Amendment Notice 2

Licence Number	L8678/2012/1
Licence Holder	Atlas Iron Limited
ACN	110 396 168
File Number:	2012/005843
Premises	Mt Dove DSO Project Mining Tenement M47/1449 and L45/248 INDEE WA 6721
Date of Amendment	06/02/2018

Amendment

Figure 1: Site layout

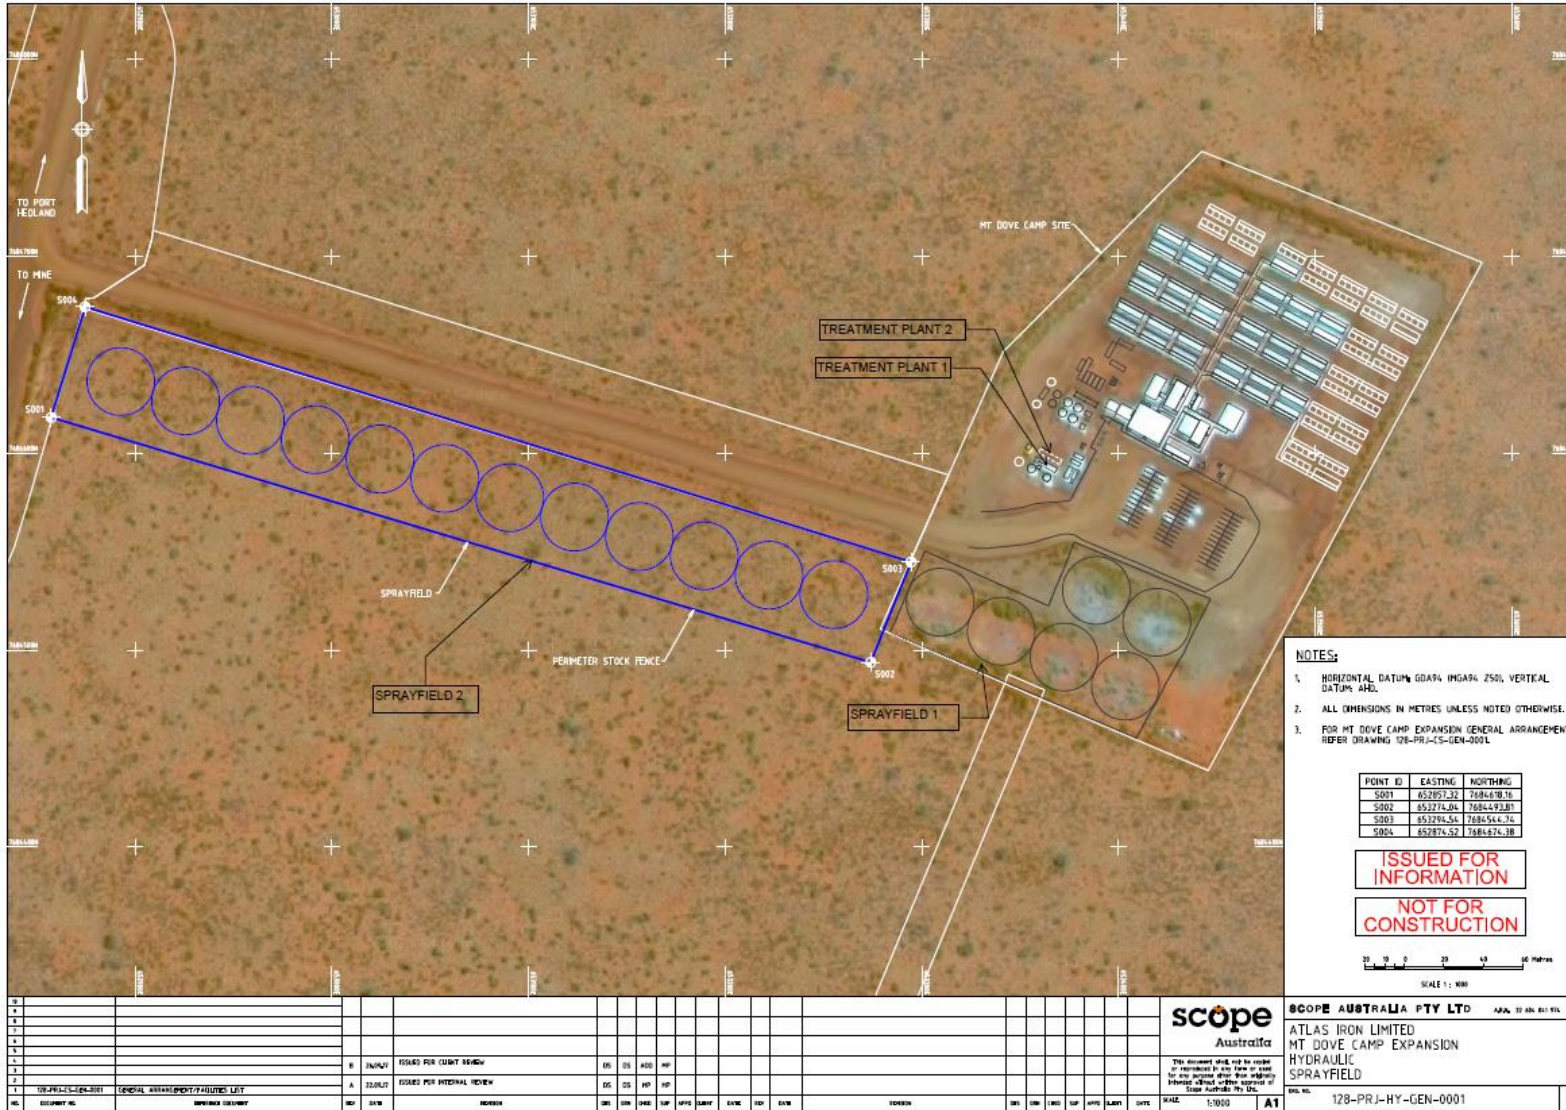
The Licence Holder (Atlas Iron Limited, also referred to as Atlas) currently crushes and screens iron ore at the premises. The location of the crushing and screening facility is shown in Figure 1 below.

Atlas proposes to crush an additional type of ore (spodumene) and increase the total approved category 5 throughput to 3 Mtpa. No modifications will be made to the processing plant.

Plan of WWTP and spray fields

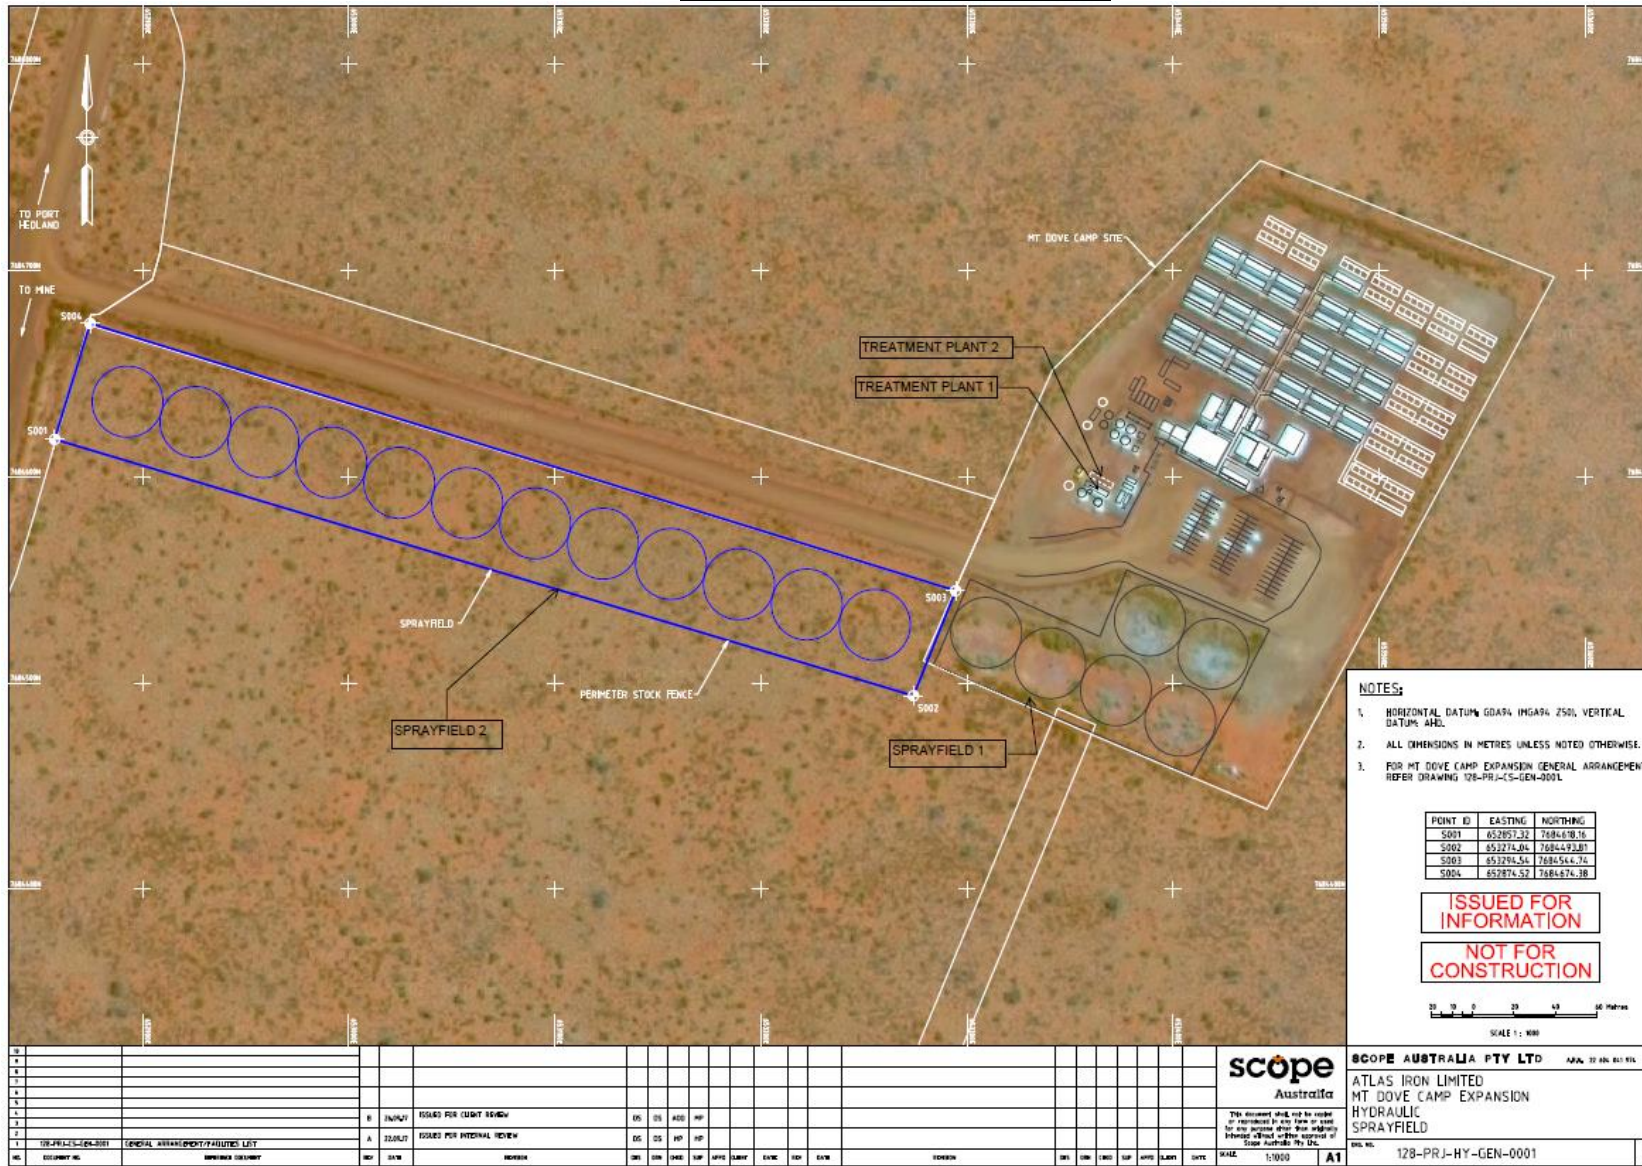
5. The Licence is amended by the insertion of the following map in Attachment 1 named Plan of WWTP and spray fields as shown below.

<p><u>m³ storage of treated effluent and brine.</u></p> <p>Final storage tank to allow for mixing of brine and effluent prior to discharge.</p> <p><u>Treated effluent and brine discharged to a spray field.</u></p> <p><u>Indicative location of WWTP as shown in Attachment 1: Plan of WWTP and spray fields.</u></p>
<p><u>Spray fields</u></p>	<p><u>Total area 3.8 hectare.</u></p> <p><u>Indicative location of spray fields as shown in Attachment 1: Plan of WWTP and spray fields.</u></p>
